City of Biddeford
Staff Review Committee
September 28, 2022 1:00 PM Second Floor Conference Room & Zoom
<https://biddeford.zoom.us/j/96455023071>
Webinar ID #964 5502 3071

STAFF REVIEW COMMITTEE REPORT

RE: 2022.35 Site Plan review for Southern Maine Health Care to build a bus shelter and access sidewalks at 1 Medical Center Drive (Tax Map 2, Lot 50) in the M-Medical Zone.

**Subject: City Review Comment Response
Bus Stop – Southern Maine Health Care**

VERTICAL GRANITE CURB
NOT TO SCALE

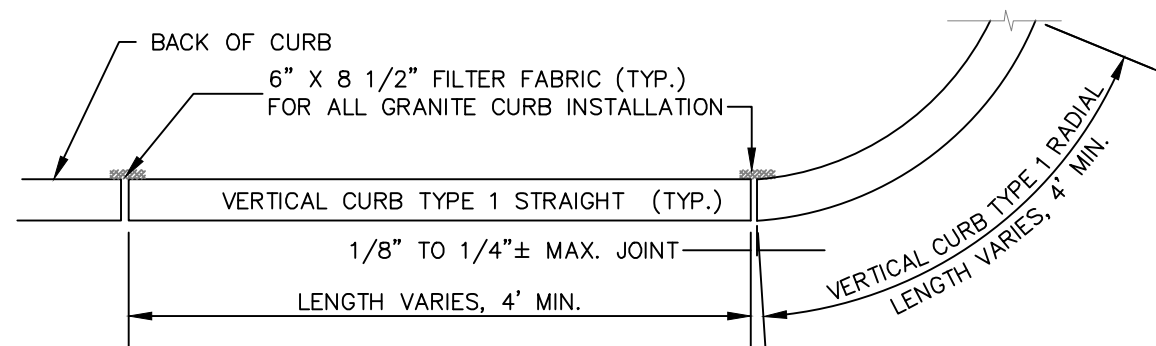
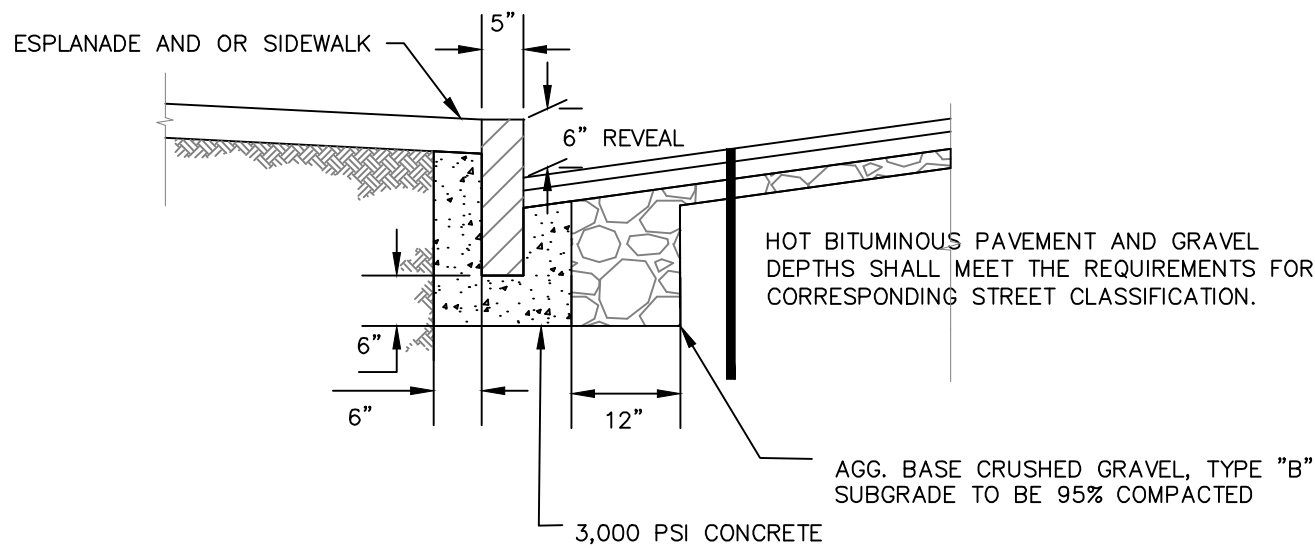
14. Vertical depth of the proposed granite curb should be specified
15. Is the 'Bus Shelter Siting' detail applicable? If so – where? The dimensions/layout does not match plan view
16. No gravel is proposed underneath the 6" concrete pad?

14. Vertical depth of the proposed granite curb should be specified.
Note 2 of the details calls for a minimum depth of the concrete backing for the curb to be ten inches, the curb must be a minimum of this depth plus the concrete sidewalk depth of 4 inches which equals 14 inches. Most granite curbing is 16-18 inches deep and should satisfy the proposed detail.
15. Is the 'Bus Shelter Siting' detail applicable? If so – where? The dimensions/layout does not match plan view
Agreed, this detail has been taken off the updated plans, the location of the shelter shall be sited per the site plan, Sheet C-10.
